Service Letter SL 41 R1	DO - No. EASA.21J.020
--	------------------------------------	----------------------------------

Optional Replacement of Return Spring, part no. A-880, by new Return Spring, part no. A-1772 and A-1771-1.

MTV-12- ()-C-F

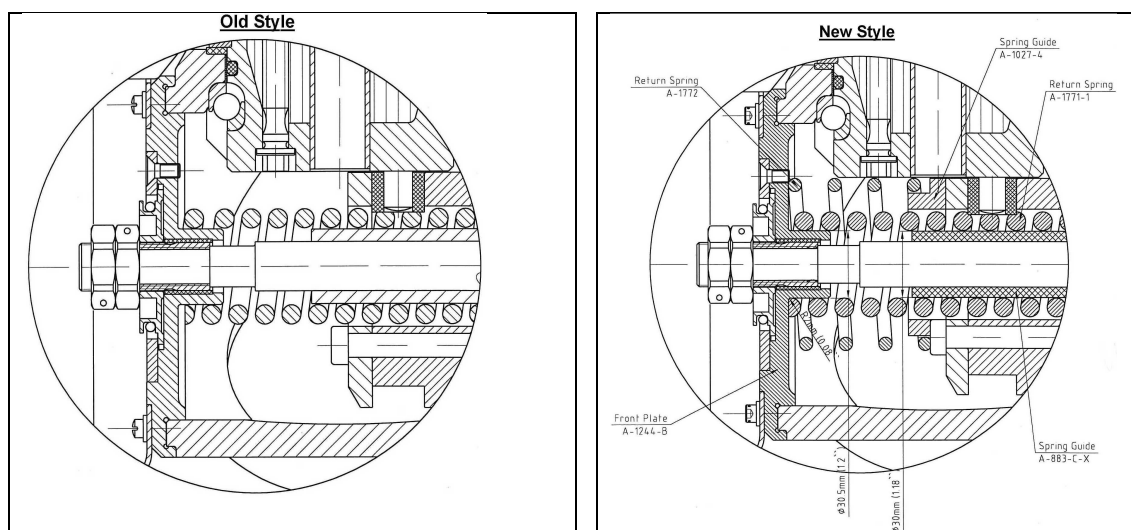
Under some circumstances the pitch change behavior is sluggish.

Due to installation of stiffer return springs the pitch change behavior is improved.

Due to the replacement of the return spring also other parts have to be exchanged and/or modified in this connection as well as according to the information as listed below.

MTV-12-()-C-F	Pieces	Old Style	New Style
Return Spring	1	A-880	A-1771-1
Return Spring	1	---	A-1772
Front Plate	1	A-1244-A	A-1244-B or modification according to drawing "New Style"
Spring Guide	1	A-883-B-X	A-883-C-X or modification according to drawing "New Style"
Spring Guide	1	--	A-1027-4
